SUSQUEHANNA STEAM ELECTRIC STATION - UNIT 2  
FINAL REPORT OF A DEFICIENCY INVOLVING  
ISOLATION OF THE NITROGEN MAKEUP SYSTEM  
ER 100508 FILE 821-20  
PLA-1990

Reference: PLA-1902 dated October 10, 1983

Present Unit 2 N<sub>2</sub> Makeup System

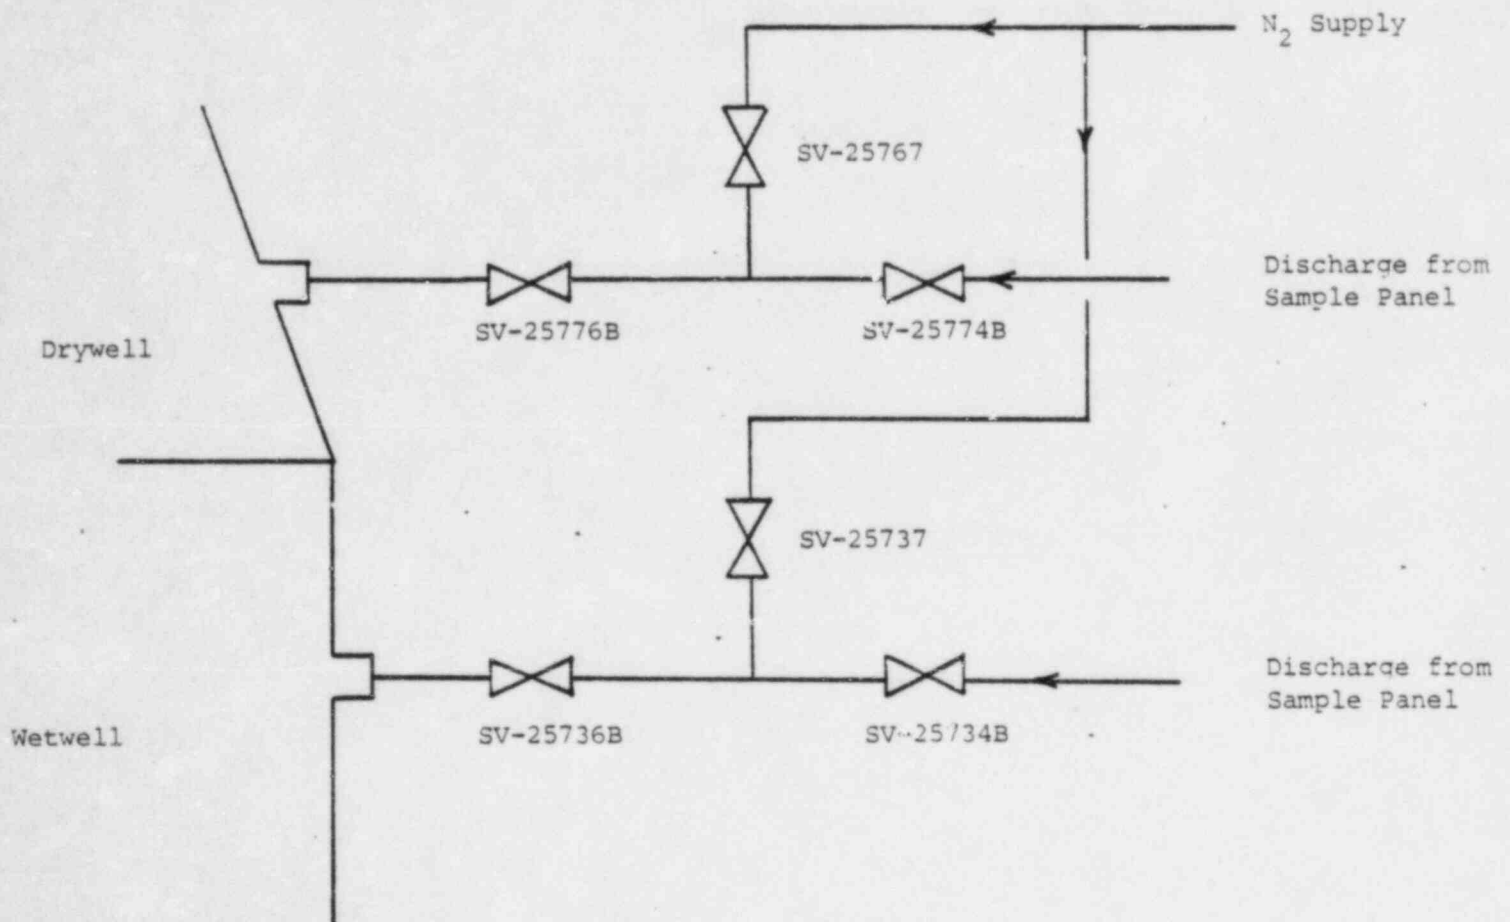
The permanent modification will consist of rerouting the drywell and wetwell nitrogen makeup lines to spare penetrations and install divisionalized isolation valves. (See attachments.) The new isolation valves will be identical to the existing SV-25767 and SV-25737. The inboard valves will be Division I power and logic and the outboard will be Division II. Each valve will have a separate handswitch located in the control room. The isolation signals will be identical to the existing system.

The permanent modification discussed above will be installed prior to initial criticality via DCP-83-745. It should be noted that PMR 83-536 which was referenced in the interim report has been superseded by PMR 83-745.
